I-26 ASHEVILLE CONNECTOR

Buncombe County, North Carolina Federal Aid Project No. NHF-26-1(53) WBS Element 34165.1.2 STIP I-2513

FINAL ENVIRONMENTAL IMPACT STATEMENT VOLUME 2 OF 2

U.S. Department of Transportation
Federal Highway Administration
and
North Carolina Department of Transportation

Figure 10: Existing, NCDOT proposed, and City alternative design for the Captain Jeff Bowen Bridges

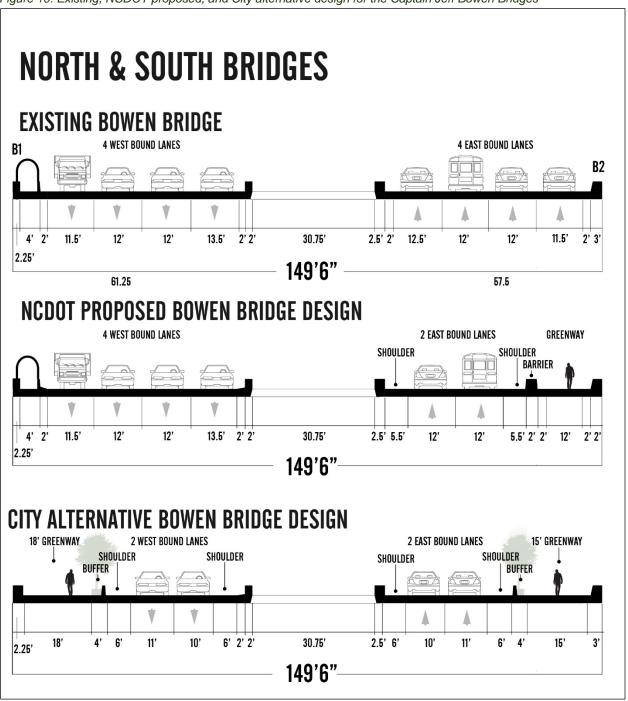
This alternative configuration has the key benefits of providing generous pedestrian and bicycle space on both bridges and calming traffic on this long stretch of roadway between traffic signals, while still being able to provide additional storage space to sufficiently accommodate queuing vehicles at the signalized intersections to the east and west of the Captain Jeff Bowen Bridges. AECOM has confirmed that the westbound bridge could theoretically be narrowed to 2 or 3 lanes but would likely have to widen to 4 lanes as it approaches the interchange with I-26/I-240. Further, while the state has committed to the multi-use path on the eastbound bridge, any such improvement on the westbound bridge may have to paid for by the City.

As described above, the City recommends "right-sizing" the vehicular lanes on the bridges and creating pedestrian and bicycle connections over both spans of the bridge, per Figure 10.

Figure 2 - NCDOT Design Concerns

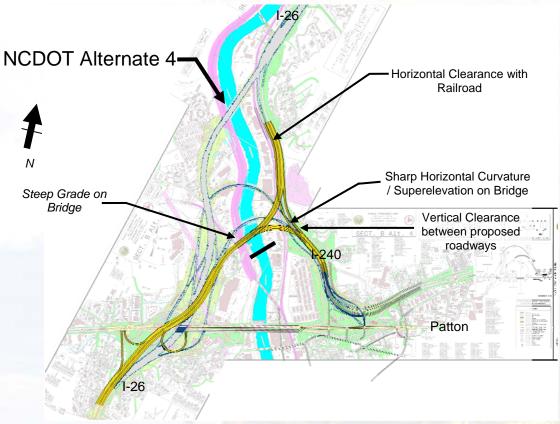
- 6. The grade on I-240 EB ramp (west side of river) required to provide the necessary vertical clearance over I-26 (at the double deck bridge) is acceptable. However, the profile on I-240 WB ramp (west side of river) required to provide the necessary vertical clearance over I-26 (at the double deck bridge) is not acceptable. Unlike the I-240 EB lanes, the I-240 WB lanes are at the low point of the 6% super-elevation prior to passing over I-26. This condition requires a steep grade approaching the double deck structure. There is also a low point on the structure which is unacceptable to the NCDOT. NCDOT does not allow sag profile low points on structures.

- 9. Operational issues (queue storage and weave distances) were identified as questionable at the following locations:
 - a. I-240 EB Exit Ramp to Patton

Figure 3 - NCDOT Environmental Concerns

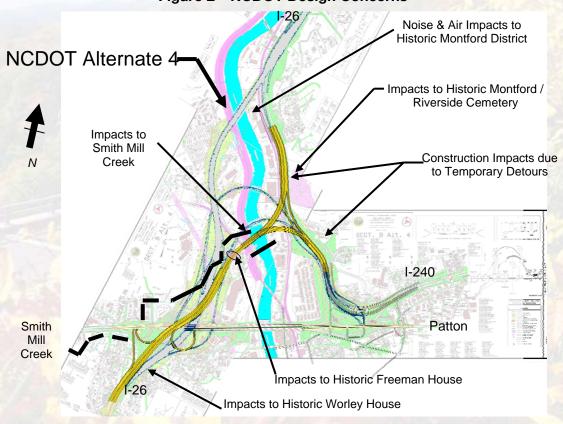
The following figures illustrate the major design, environmental and operational concerns raised by the NCDOT.

Figure 17 – Alternative 4B Braided Ramp Concept (see appendix for 11" X 17" print)

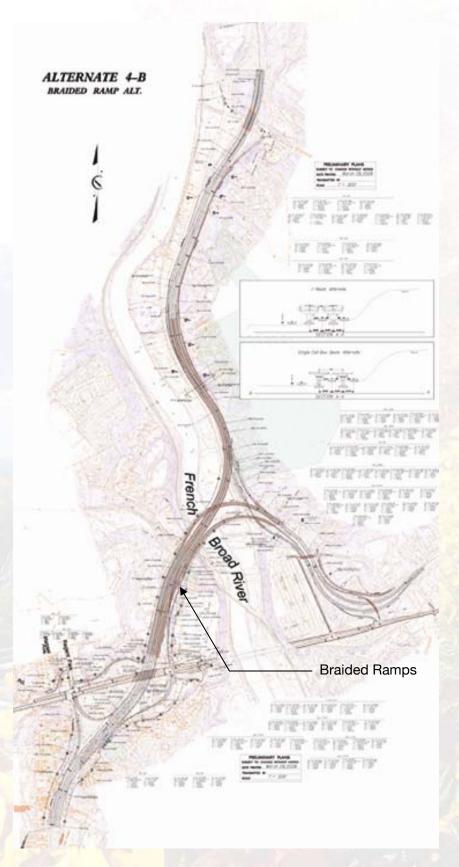
This new revised Alignment 4B (see Figure 17) was submitted to the NCDOT on March, 28, 2008 for their continued review.

Concurrent with development of the braided ramp option, the FIGG Team also prepared responses to constructibility comments that were received on April 9, 2008 from the Traffic Control Project Engineer and Division 13 Construction Engineer. On April 9, 2008 the FIGG Team provided responses to the construction comments received. See Appendix E for a copy of the construction comments and associated responses.

Figure 18 – Alternative 4B I-26 over Patton Avenue Concept (see appendix for 11" X 17" print)

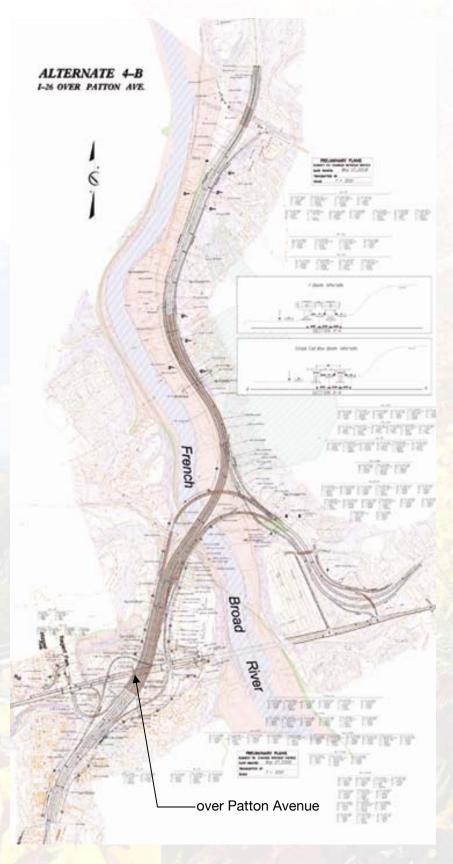
This newest revised alignment as shown in Figure 18 that addressed the NCDOT comments from the April 16, 2008 meeting was discussed with the City of Asheville and the ADC and subsequently submitted to NCDOT for their continued review on May 27, 2008.

After discussing the review comments, NCDOT noted that no fatal flaws had been identified with the concept as shown in Figure 18, and NCDOT would proceed with this alternative into preliminary design for inclusion in the NEPA process. NCDOT also noted that this alternative would be presented as a Corridor Hearing/Public Workshop map.
